CITY PLAN COMMISSION STAFF REPORT

Project Name
303 Broadway

Request
CD-CPC-2023-00026
Development Plan

Docket #6 Recommendation
Approval with Conditions

1 NORTH ELEVATION
1/8" = 1'-0"

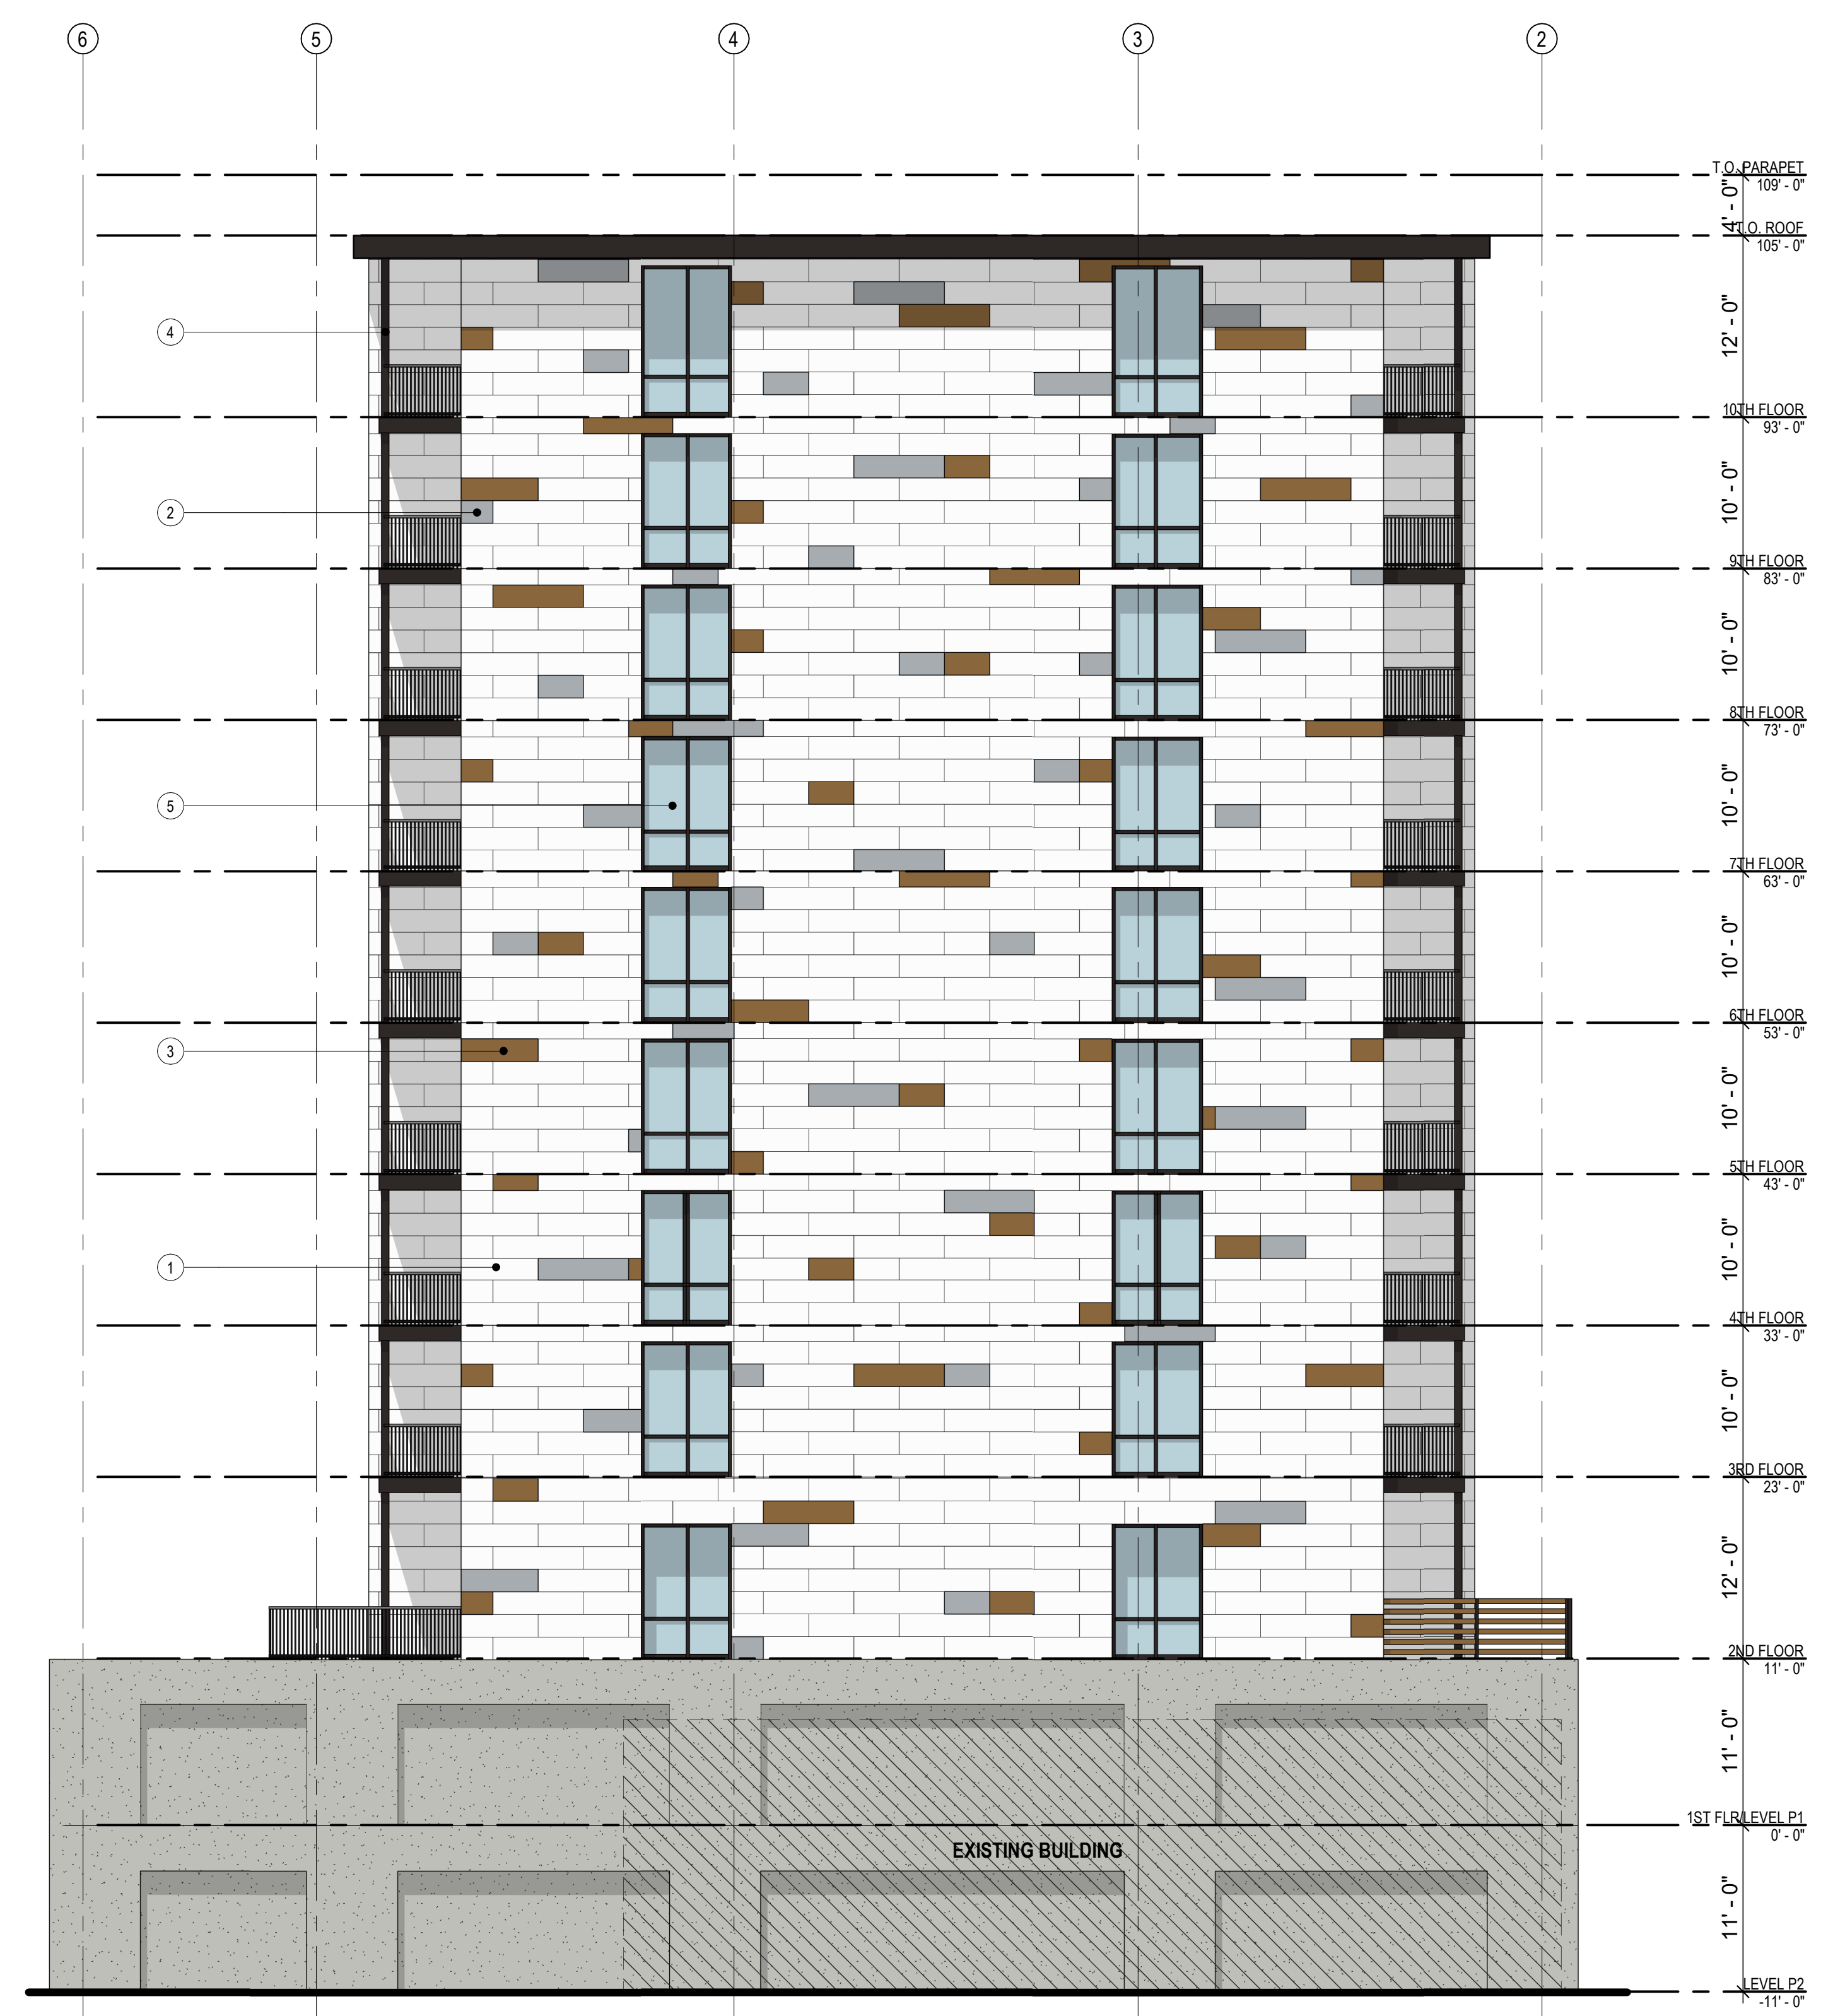
The majority of the lot is taken up by the building, the applicant is proposing alternative landscaping options throughout the development to meet the requirements. There is one section on the Northeast corner of the building that is blank concrete, the developer added a 4-inch indent to add some architectural distinction, however staff has included a condition requiring the developer to continue to work with staff to determine a suitable alternative for the corner prior to building permit.

8. The developer shall work with staff to find a suitable alternative to the section of blank concrete on the northeastern corner of the building prior to building permit.
